SUBJECT: AMENDMENT NO. 191 TO FACILITY OPERATING LICENSE NO. NPF-3 -
DAVIS-BESSE UNIT NO. 1 NUCLEAR POWER STATION, (TAC NO. M89365)

Amendment No. 191
License No. NPF-3

SAFETY EVALUATION BY THE OFFICE OF NUCLEAR REACTOR REGULATION
RELATED TO AMENDMENT NO. 191 TO FACILITY OPERATING LICENSE NO. NPF-3
TOLEDO EDISON COMPANY
AND
THE CLEVELAND ELECTRIC ILLUMINATING COMPANY
DAVIS-BESSE NUCLEAR POWER STATION, UNIT 1
DOCKET NO. 50-346

Figure 3.1-1 Boric Acid Addition System
Minimum Required Volume as
a Function of Boric Acid
Concentration Required in
Modes 1-4

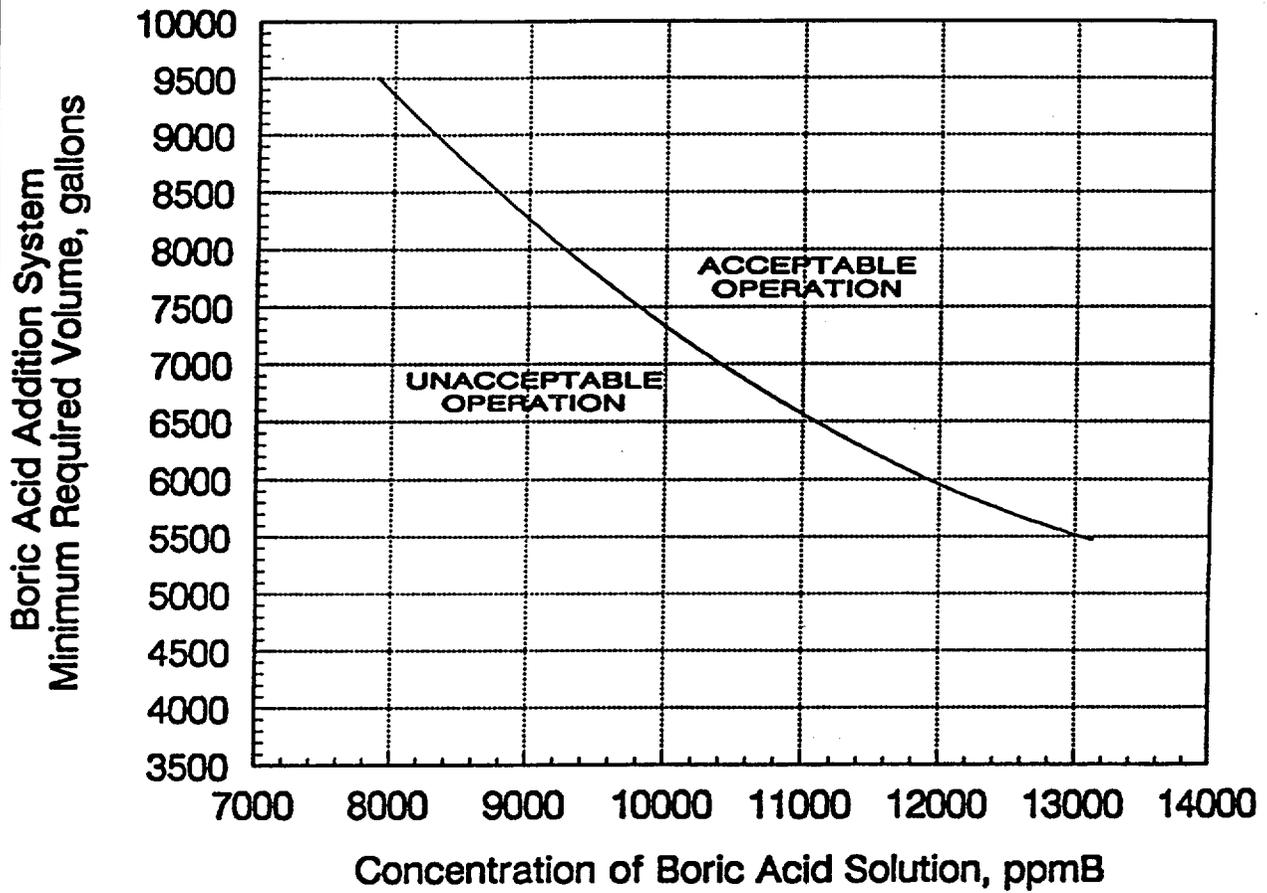
- (4) TS 3.1.2.9, Figure 3.1-1 - Increase the minimum borated water volume corresponding to different boron concentrations in the BAAS.
- (5) TS 3/4.5.1 - Increase the minimum boron concentration in the Core Flooding Tanks (CFT) to the same concentration as in the BWST (2100 ppm).

Proposed changes to TS 3/4.1.2.9 and TS 3/4.5.4, applicable during Modes 1, 2, 3, and 4, would revise TS Figure 3.1-1 and increase the minimum required BWST boron concentration from 1800 ppm to 2100 ppm. The boration capability of the BWST and the BAAS must be sufficient to provide a shutdown margin from all operating conditions of 1% after xenon decay and cooldown to 200 °F. The maximum boration capability requirement occurs from full power equilibrium xenon conditions and requires the equivalent of 9071 gallons of 7875 ppm borated water from the BAAS or 75,300 gallons of 2100 ppm borated water from the BWST. This requirement is met by the proposed changes and bounded by the proposed new Figure 3.1-1. The proposed changes are, therefore, acceptable.

- a. The boric acid addition system (BAAS) with:
 1. A minimum available borated water volume in accordance with Figure 3.1-1,
 2. Between 7875 and 13,125 ppm of boron, and
 3. A minimum solution temperature of 105°F.
- b. The borated water storage tank (BWST) with:
 1. An available borated water volume of between 482,778 and 550,000 gallons,
 2. Between 2100 and 2200 ppm of boron, and
 3. A minimum solution temperature of 35°F.
